Access Compliance Report Public Rights-of-Way (Curb Ramps)

Main Street: TERRASTAR_LN Cross Street: CAPRICORN_DR Location: SW

ADA ID: RPAT211101100843 Ramp Type: Type 4 - Parallel Initial Pass/Fail: Fail Overall Compliance: No Severity Score: 15

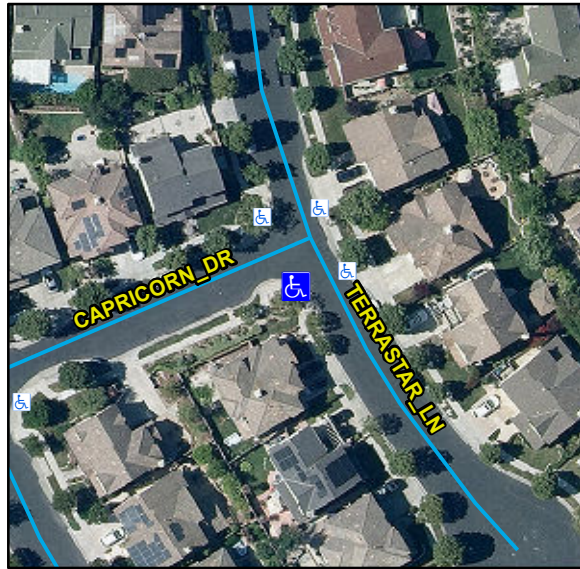
Compliance	Description	Data	Compliance	Description	Data
N/A	Ramp Length LT (in)	110	N/A	Ramp Length RT (in)	100
Yes	Ramp Width LT (in)	53	Yes	Ramp Width RT (in)	53
No	Ramp Run Slope LT (%)	10.7	Yes	Ramp Run Slope RT (%)	1.2
Yes	Ramp Cross Slope LT (%)	0.6	Yes	Ramp Cross Slope RT (%)	1.1
N/A	Landing Present	N/A	N/A	DWS Provided	N/A
N/A	Landing Length (in)	N/A	N/A	DWS Contrast	N/A
N/A	Landing Width (in)	N/A	N/A	DWS Length (in)	N/A
N/A	Landing Run Slope (%)	N/A	N/A	DWS Full Width	N/A
N/A	Landing Cross Slope (%)	N/A		DWS Offset Type	N/A
N/A	Landing Movement Obstructed?	N/A	N/A	DWS Offset Left (in)	N/A
	Landing Movement Type	N/A	N/A	DWS Offset Right (in)	N/A
N/A	Landing Shared	N/A			
N/A	Clear Space	Yes			
N/A	Clear Space To Crosswalk (in)	N/A			
N/A	Marked Crosswalk 1	No	N/A	Marked Crosswalk 2	No
	Crossing 1 Direction	E		Crossing 2 Direction	N
N/A	Marked Crosswalk 1 Width (in)	N/A		Marked Crosswalk 2 Width (in)	N/A

Remove & Replace Curb Ramp With Two New Directional Ramps or Equivalent.
